ATTACHMENT 1

Proposed McGuire Unit 1 and 2 Technical Specifications Changes

ATTACHMENT 2

Justification and Safety Analysis

Figure 1 - Illustration of McGuire 125 VDC Vital Instrumentation and Control Power System

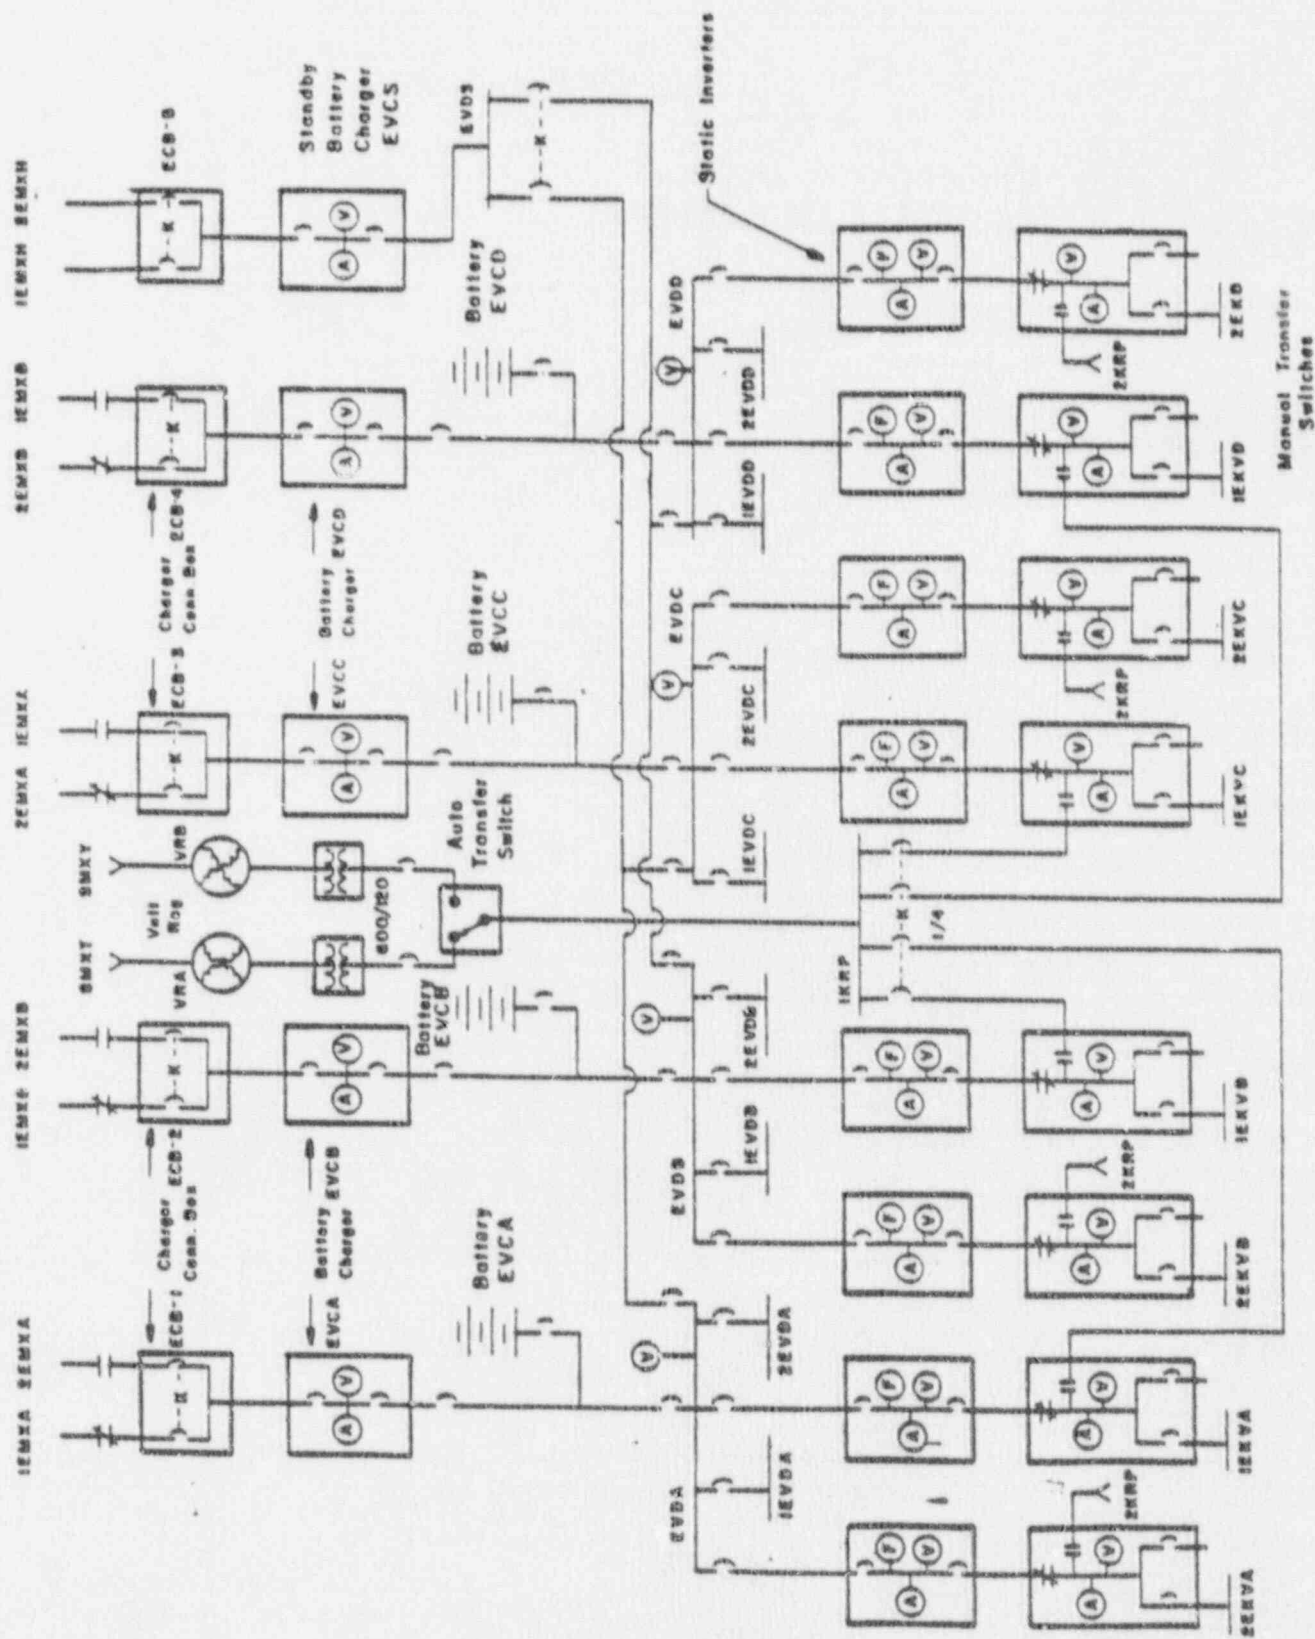
The 125 VDC Vital Instrumentation and Control Power System provides a source of reliable continuous DC power for safety related control and instrumentation. This system, which is shared between the two McGuire units, is divided into four independent and physically separated load groups, each load group being comprised of one battery, one battery charger, one DC distribution center, and two DC power panelboards.

Figure 1 depicts a general illustration of the 125 VDC Vital Instrumentation and Control Power System, including the batteries.

During the time period that the battery banks are being replaced, a temporary battery bank will be installed and connected to the affected 125 volt bus so that the bus remains battery backed at all times. The temporary battery bank will be located in Room 700 of the McGuire Service Building (Shared Load Center Room) and will be tied to the DC side of the standby battery charger EVCS via EVDS distribution center breaker 1B using temporary cable. Figure 3 depicts the location of the temporary battery and cabling. Depending upon which battery bank is being replaced, the temporary battery will either be one of the AT&T

Figure 2 - AT&T LINEAGE 2000 Round Cell Battery (Cutaway View)

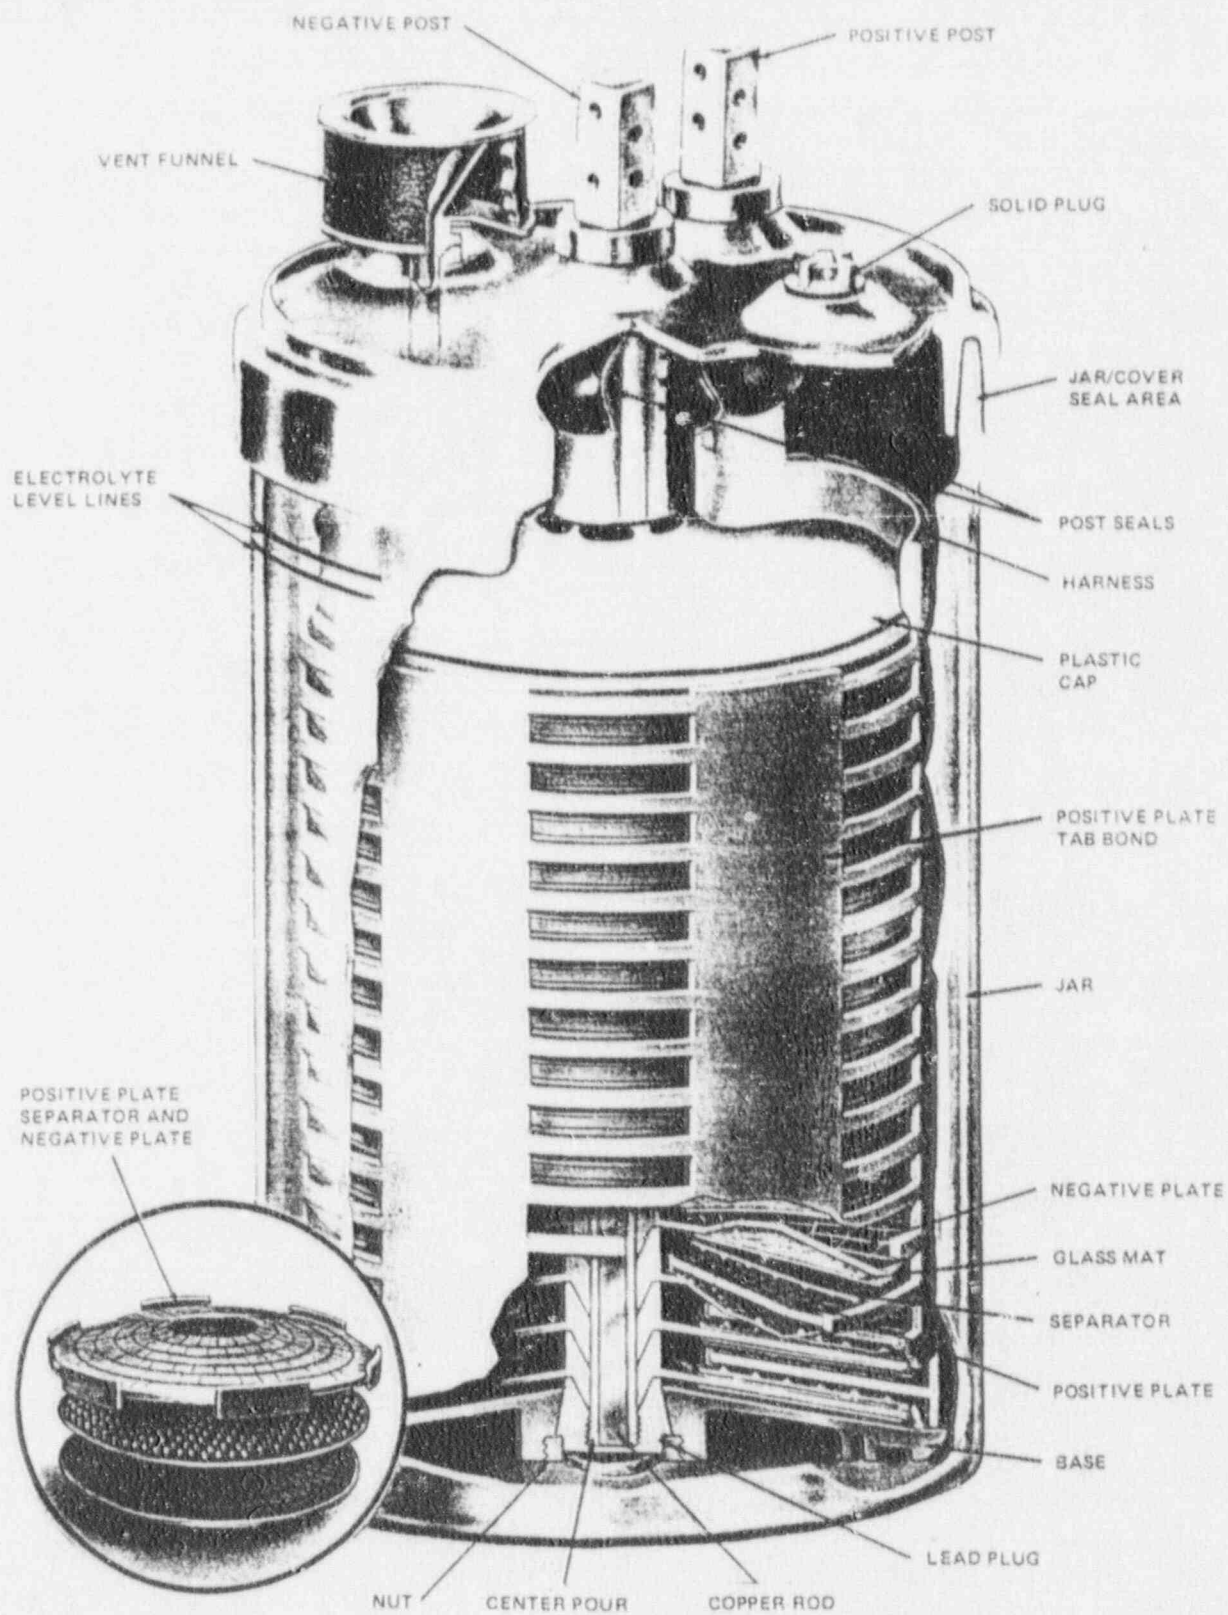
The battery selected for replacement is the AT&T LINEAGE 2000 Round Cell Battery. This battery (see Figure 2) is a secondary, lead-acid, flooded cell designed by AT&T Bell Laboratories. The specific size (model) selected for McGuire is Model KS-20472, List 1SH (1850 Ampere Hours). Table 1 below lists characteristics of the replacement batteries.
